Subject: **Response to Portion of NRC RAI Letter No. 290 Related to ESBWR Design Certification Application - DCD Tier 2 Section 3.7 – Seismic Design; RAI Number 3.7-63 S02 Revision 1**

**Response to NRC RAI Letter No. 290  
Related to ESBWR Design Certification Application<sup>1</sup>**

**DCD Tier 2 Section 3.7 – Seismic Design**

**RAI Number 3.7-63 S02 (Revision 1)**

**Figure 3.7-63(1) Comparison of Surface Response Spectra for Layered Case 2 when the Input Motion is applied at Different Levels**

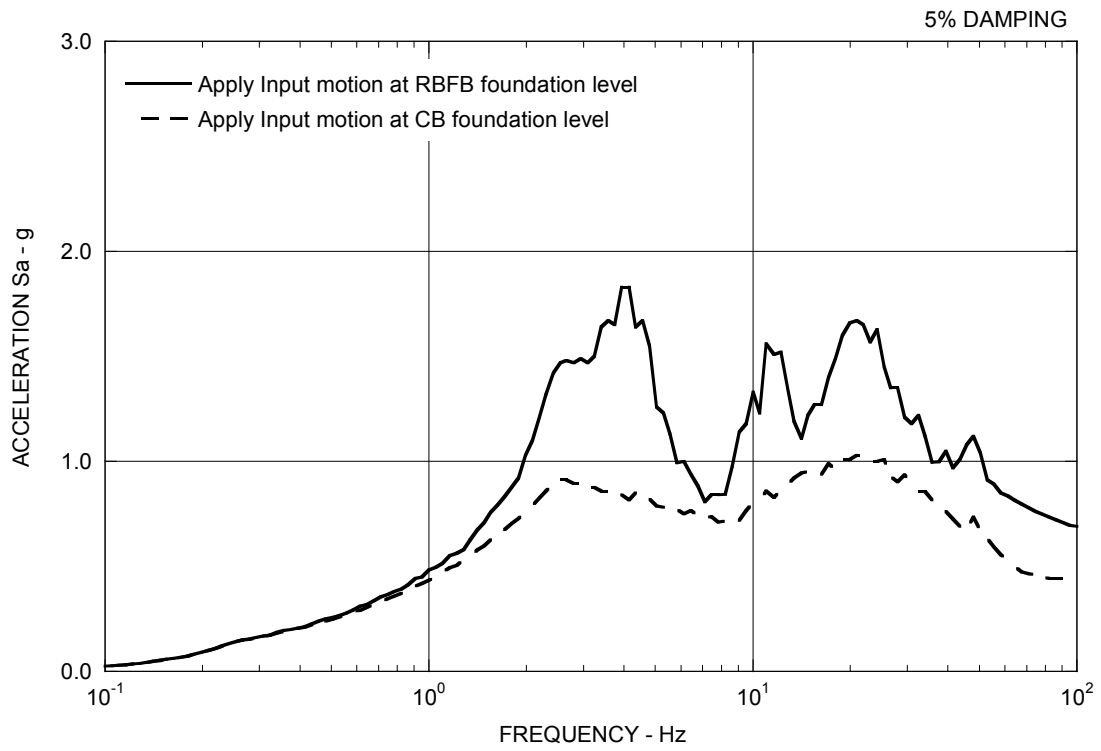
- (a) Based on the first two sentences above, it appears to the staff that the ground motion for the CB was applied at two different elevations: at the CB foundation level for the generic sites defined in Subsection 3A.3.1, and at the RFBF foundation level for the layered site cases. Please confirm this, or clarify what was actually done. If this is the case, please describe what differences in CB response would be expected for the layered site cases if the input ground motion had been defined as an outcrop motion at the CB foundation level.*

*In reviewing Figure 3.7-63(1), the staff noted that the surface spectra corresponding to placing the input motion at the bottom of the CB foundation (dashed line) does not appear to be correct. It resembles the spectrum of the input motion, at the foundation level. The dashed line would be expected to exhibit the same pattern of peaks and valleys as the solid line. GEH needs to confirm that the dashed line is correct, and provide an explanation for the unexpected shape.*

*Applying the outcrop motion at the RFBF foundation level for the layered site cases is a more conservative approach than applying the outcrop motion directly at the CB foundation level. This is demonstrated in Figure 3.7-63(1) by comparing the response spectra of the surface motion when the ground motion is applied at the RFBF foundation level and at the CB foundation level for the typical layered site Case 2 described in DCD Tier 2 Table 3A.3-3. The response spectrum of the surface motion is larger in the case when the ground motion is applied at the RFBF foundation level than in the case when the ground motion is applied at the CB*

foundation level. Therefore, it is expected that the CB response would be smaller for the layered site cases if the input ground motion had been defined as an outcrop motion at the CB foundation level instead at the RBFB foundation level.

GEH confirms that both the solid and dashed lines in Figure 3.7-63(1) have been correctly calculated by using the method identified as the DCD Method in GEH's response to NRC RAI 3.7-16, Supplement 2 transmitted to the NRC via MFN 06-274, Supplement 2, which includes the entire soil column up to the ground surface in a single SHAKE run with outcrop motion input at the foundation level.

The reason for the dashed line resembling the foundation input spectrum is because the CB (14.9 m embedment) is shallower than the top layer (20m thick) of the layered sites (see DCD Tier 2 Table 3A.3-3). In other words, the soil properties above the foundation are the same as those below the foundation in the region of the top layer and, as a result, the surface motion resembles the foundation input motion. This can be further explained by the one-dimensional wave propagation theory below:

**Figure 3.7-63(2) Comparison of Horizontal SSE Design Response Spectrum with NA3 Site-Specific Spectra at FWSC Foundation Level (Reproduced from North Anna 3 COLA FSAR Figure 2.0-203)**

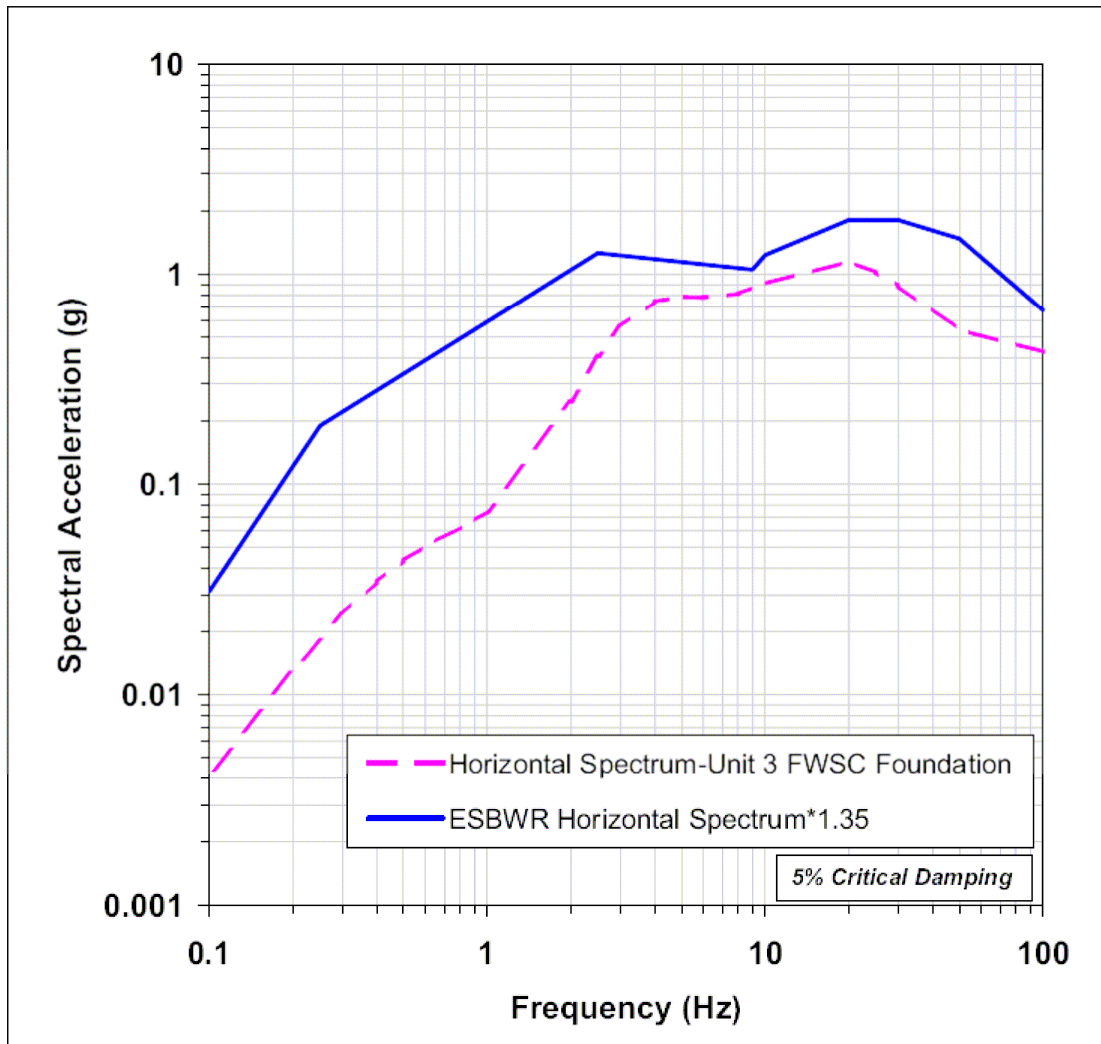
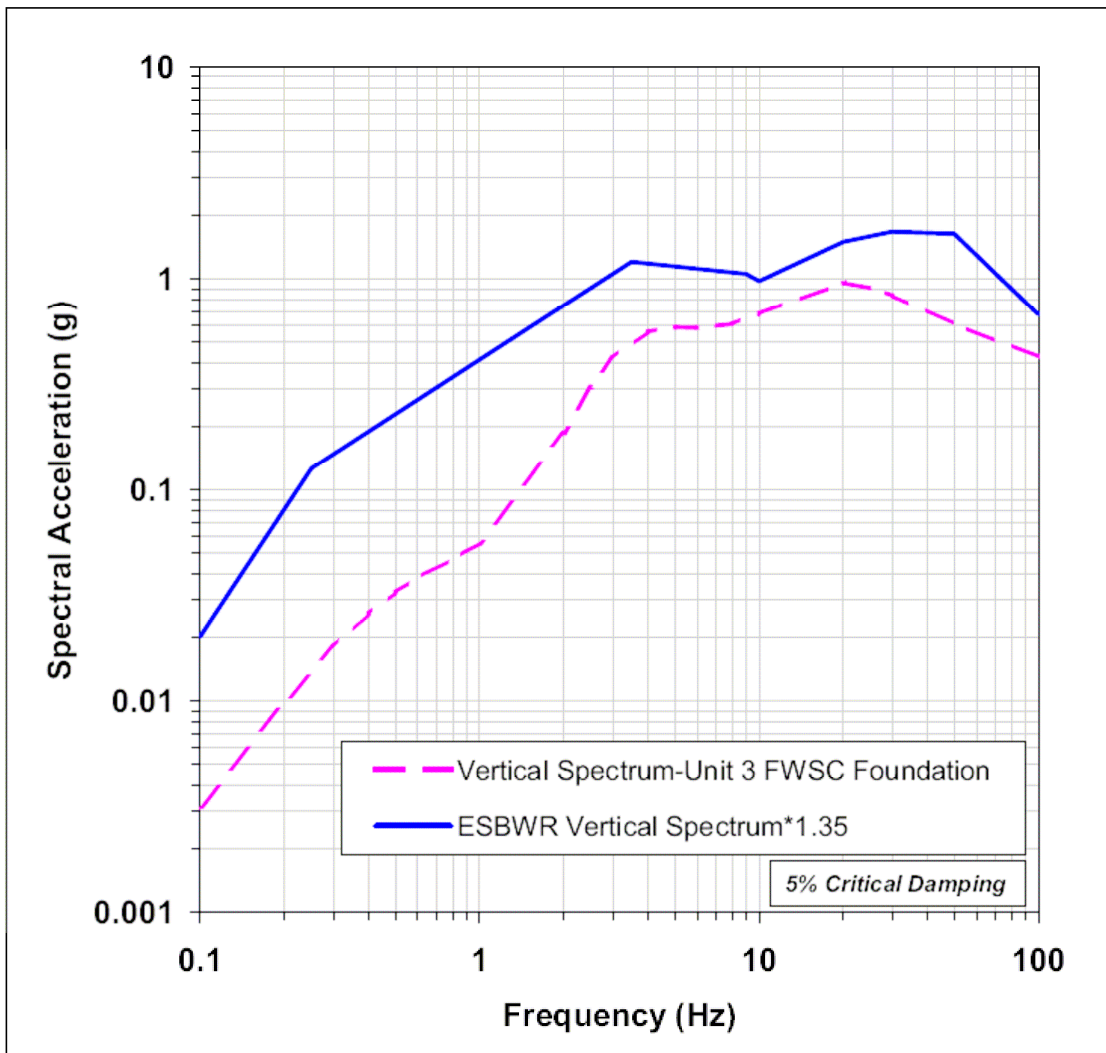
- (b) The third sentence above defines the input ground motion used for the FWSC SSI analyses as “1.35 times the RFBF/CB foundation input motion...applied directly at the foundation level.” Please provide a detailed technical basis for the selection of the 1.35 factor, including pertinent quantitative information upon which this determination is based.*

*The staff believes that the surface spectra used for seismic analysis of the FWSC should envelope the 8 surface spectral plots that the staff has asked GEH to derive under Part (1) above. This would ensure consistency between the input at the RB/FB and CB foundation levels and the input at the surface for the FWSC. GEH's proposed 1.35 factor on the input motion at the bottom of the RB/FB foundation may or may not produce a suitable envelope. Based on comparing Figure 3.7-63(1) to Figure 3.7-63(2), it appears to the staff that a 1.35 factor may not be sufficient over the entire frequency range.*

- (b) The technical basis for scaling the RBFB/CB foundation input motion for ground motions at other depths is to maintain a broad-band spectrum shape that is rich in all frequencies, regardless of site conditions, for the purpose of standard plant design. Broad-band design spectrum at any foundation depth is compatible with smooth site-specific ground motion response spectrum (GMRS) and associated foundation input response spectrum (FIRS) generated in accordance with RG 1.208 requirements for new units. The 1.35 scale factor was determined such that the resulting spectrum at the FWSC foundation level envelops the FIRS at the North Anna 3 site as shown in Figure 3.7-63(2) for the horizontal motion and Figure 3.7-63(3) for the vertical motion.

**Figure 3.7-63(4) Comparison of Surface Response Spectra for Layered Case 1**

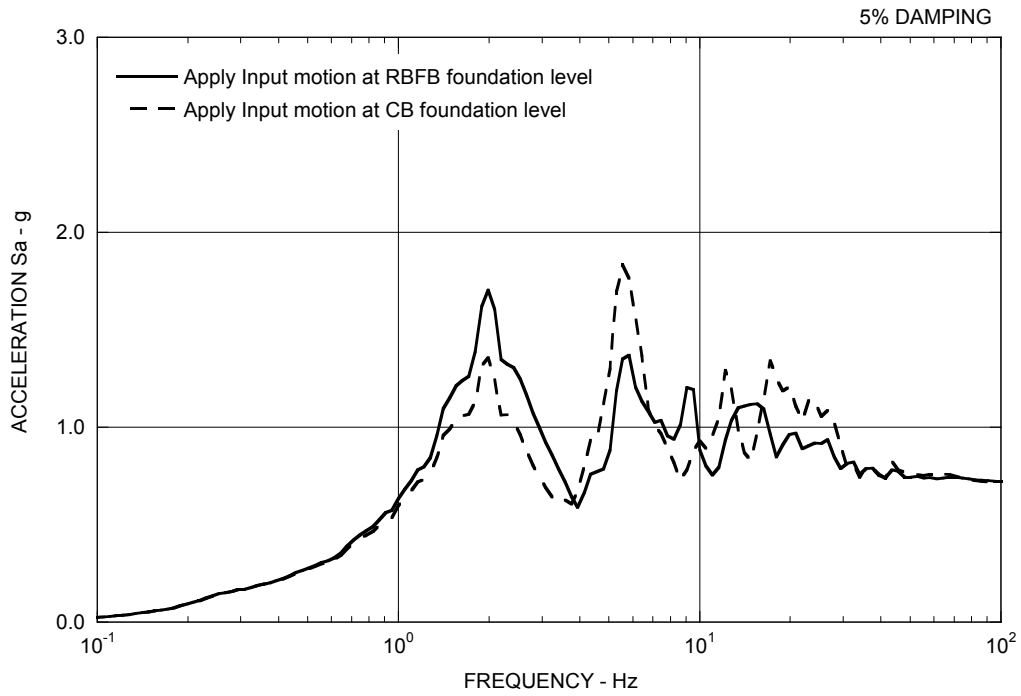
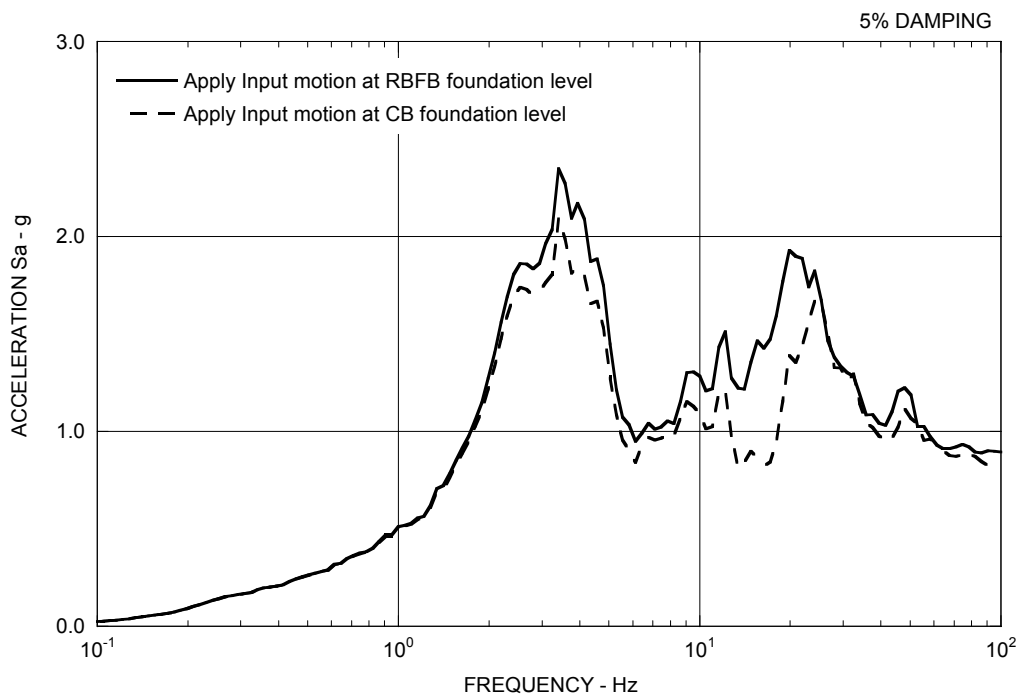
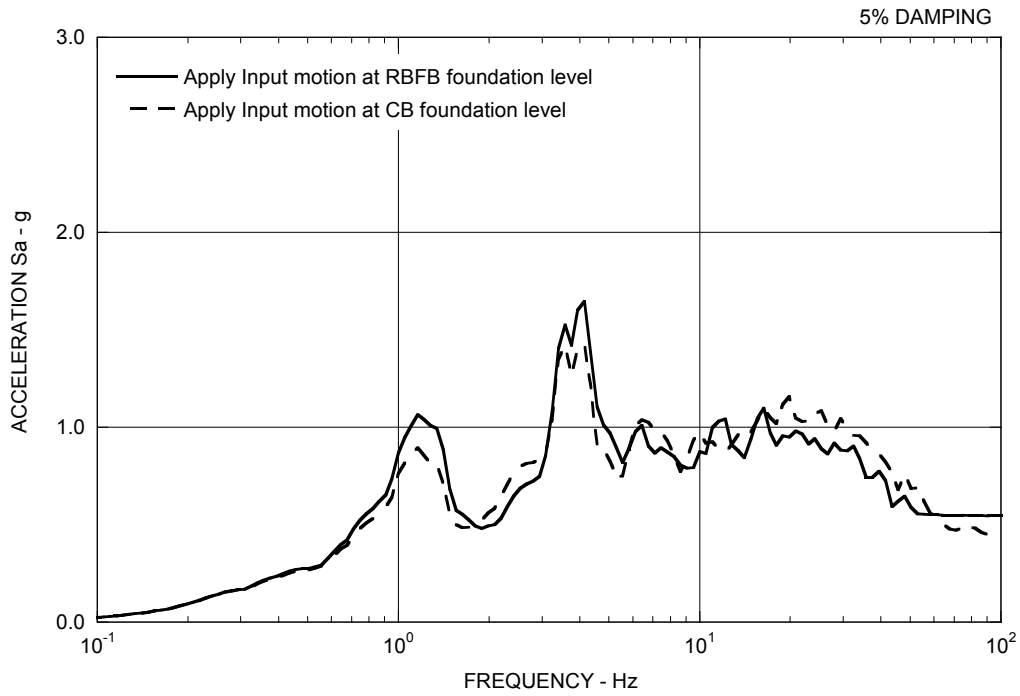
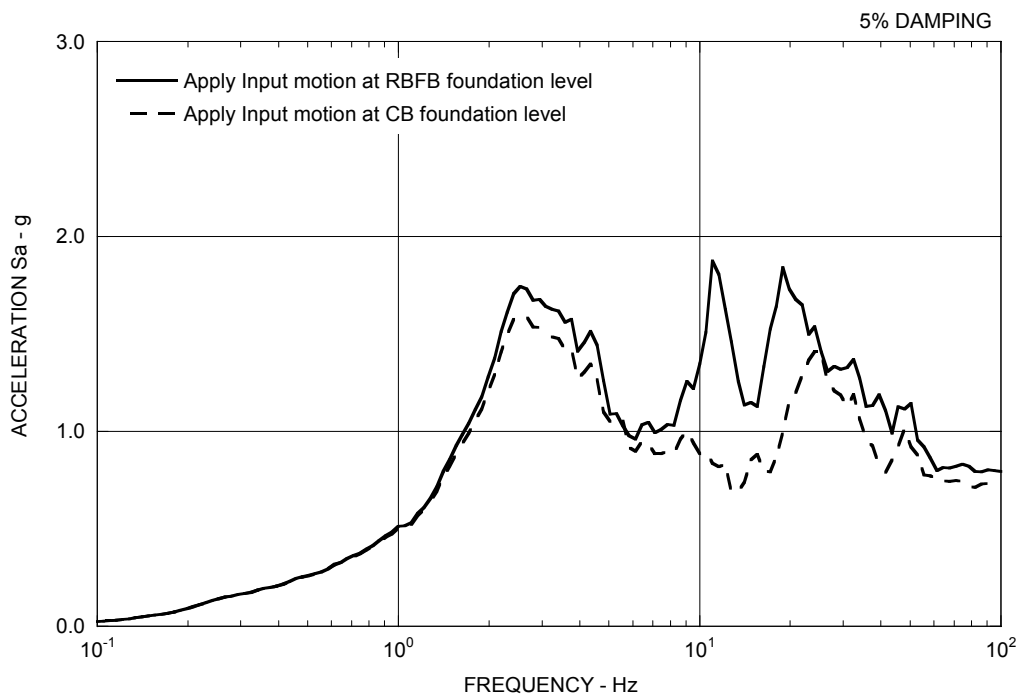
*Part (1) - GEH needs to submit a comparison of the surface spectra derived by placing the input motion at the bottom of the RB/FB foundation to the surface spectra derived by placing the input motion at the bottom of the CB foundation, for each of the 4 SASSI layered soil cases. In deriving the surface spectra from the foundation motions, the method identified as the NRC method in GEH's response to RAI 3.7-16 must be used. Submit four (4) figures, similar to Figure 3.7-63(1).*

Part (1) - Figures 3.7-63(4) through (7) show comparisons of the surface spectra derived by placing the input motion at the bottom of the RB/FB foundation to the surface spectra derived by placing the input motion at the bottom of the CB foundation for each of the 4 SASSI layered soil cases by using the method identified as the NRC Method in GEH's response to NRC RAI 3.7-16, Supplement 2 transmitted to the NRC via MFN 06-274, Supplement 2.

Since the fundamental frequencies of the CB in the horizontal directions are around 3 Hz, as shown in DCD Tier 2 Table 3A.7-8, the CB responses would be smaller for all layered site cases if the input ground motion had been applied at the CB foundation level instead at the RB/FB foundation level.

Part (2) - The surface spectra computed from the input spectra defined at the RB/FB and CB foundations, as shown in Figures 3.7-63(4) through 3.7-63(7), exhibit distinct peaks and valleys. Using these surface spectra directly as input motion could under-predict or over-predict the FWSC response depending on the SSI frequencies. The more balanced approach for the standard plant design is to maintain the broad-band characteristics in the foundation input spectra that is rich in all frequencies, regardless of site conditions. This is the technical basis for the selection of FWSC input spectra to be 1.35 times the broad-band Certified Seismic Design Response Spectra (CSDRS) for the RB/FB and CB. As stated in the original response to this RAI, the 1.35 scale factor was chosen to envelop the FWSC Foundation Input Response Spectra (FIRS) at the North Anna 3 site. To ensure the seismic adequacy of the FWSC at each site, the COL applicant is required to compare the site-specific FIRS for the FWSC with the FWSC CSDRS, which is 1.35 times the values shown in DCD Tier 2 Figures 2.0-1 and 2.0-2 as stipulated in footnote 9 to DCD Tier 2 Table 2.0-1.

Figure 3.7-63(8) Structure-Structure Interaction Analysis Model

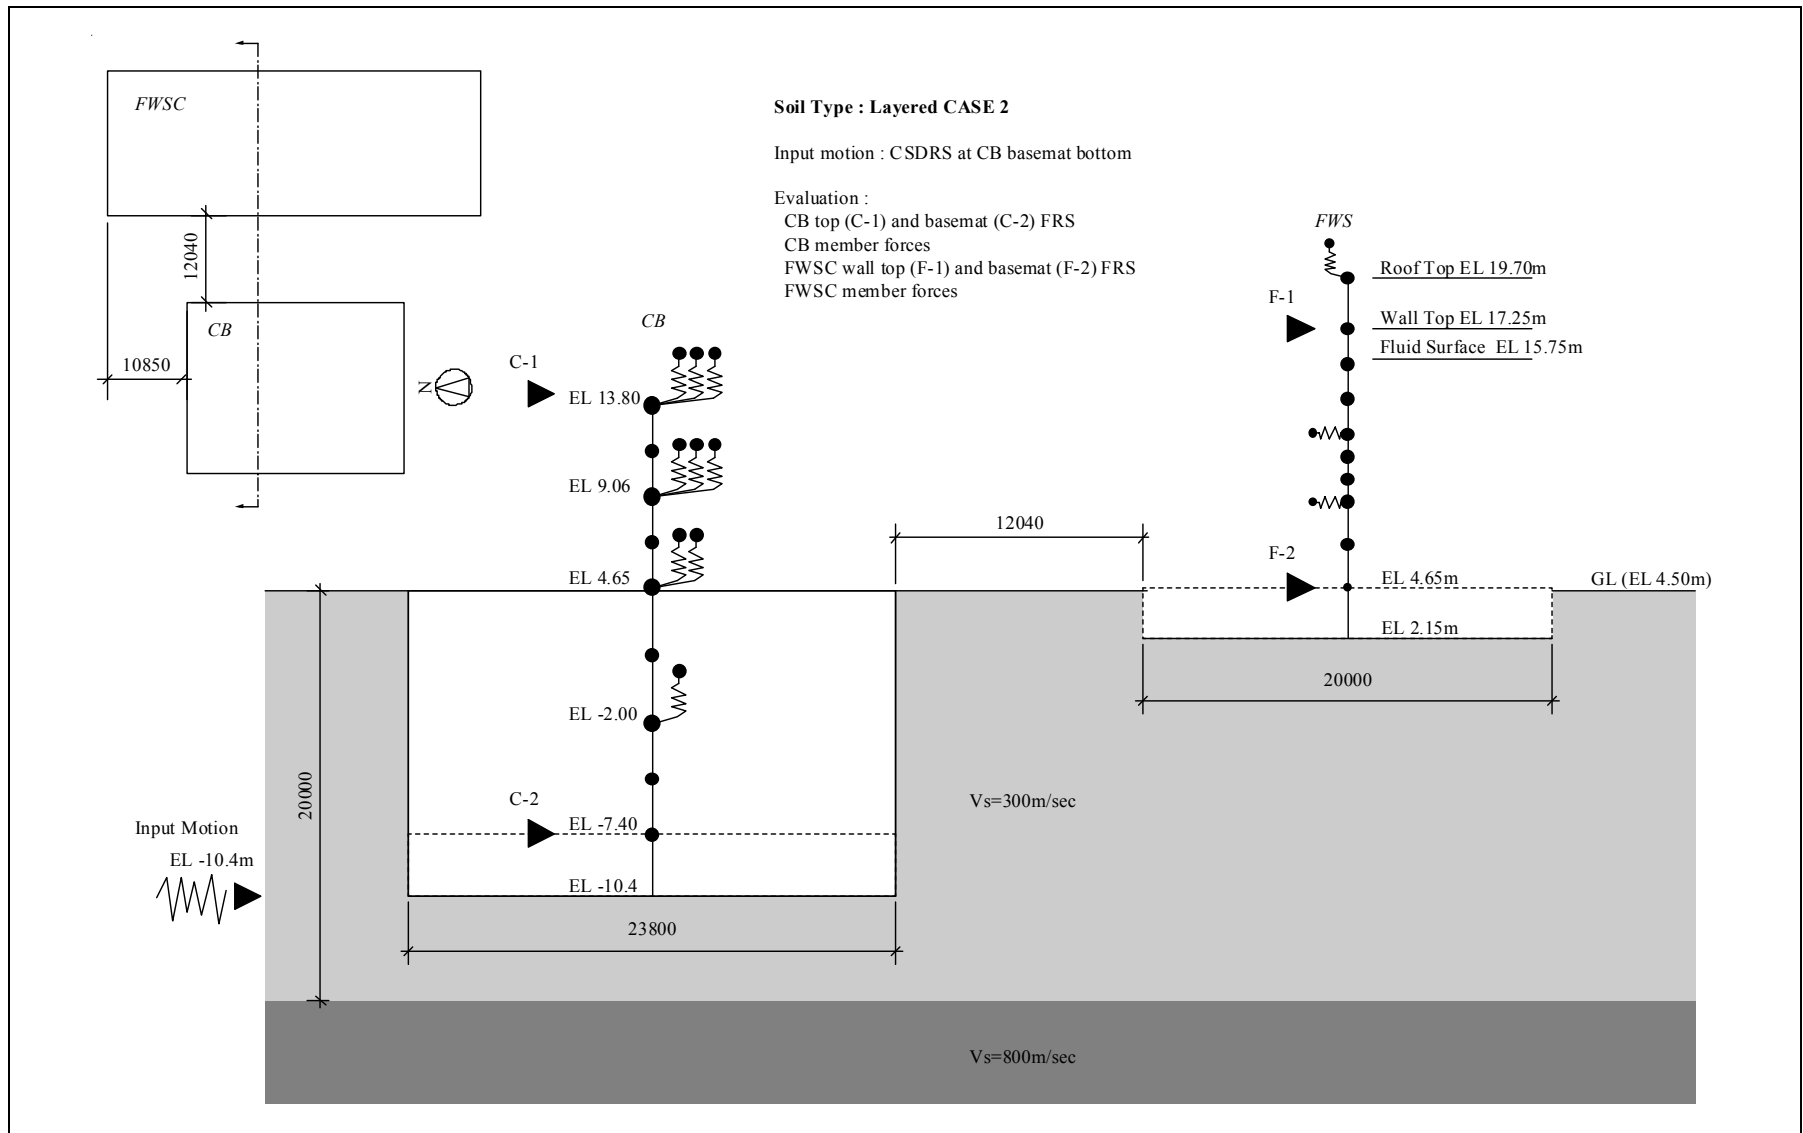
*During a teleconference on 12/10/2008 related to RAI 3.7-63 S01, the staff discussed with GEH how the potential for structure-soil-structure interaction was addressed in its evaluation of the FWSC. GEH indicated that it had not conducted any specific analysis due to the appreciable distance between the closest building (CB) and the FWSC. The staff considers that a quantitative evaluation of this potential effect is needed to address this issue. The following two approaches may be considered:*

- (1) GEH conducts a generic structure-soil-structure analysis for the FWSC.*
- (2) The COL applicant develops its site-specific FIRS for the FWSC foundation by an analysis that considers structure-soil-structure interaction effects. As long as the site-specific FIRS for the FWSC, including any interaction effects, falls below 1.35 x CSDRS, then the FWSC is seismically qualified by reference to the ESBWR DCD.*

GEH has conducted a generic structure-soil-structure interaction analysis for the FWSC with the CB.

The analysis model is composed of these two independent structures coupled through soil, as shown in Figure 3.7-63(8), using the SASSI2000 computer code. The same layered site Case 2 considered for the interaction between the RB/FB and CB is also used in the interaction between the CB and FWSC (CL-2 for CB and FL-2 for FWSC). The input motion for the coupled CB-FWSC SSI model is the Certified Seismic Design Response Spectra (CSDRS) applied at the CB foundation level. This analysis case is named Case FL-5.
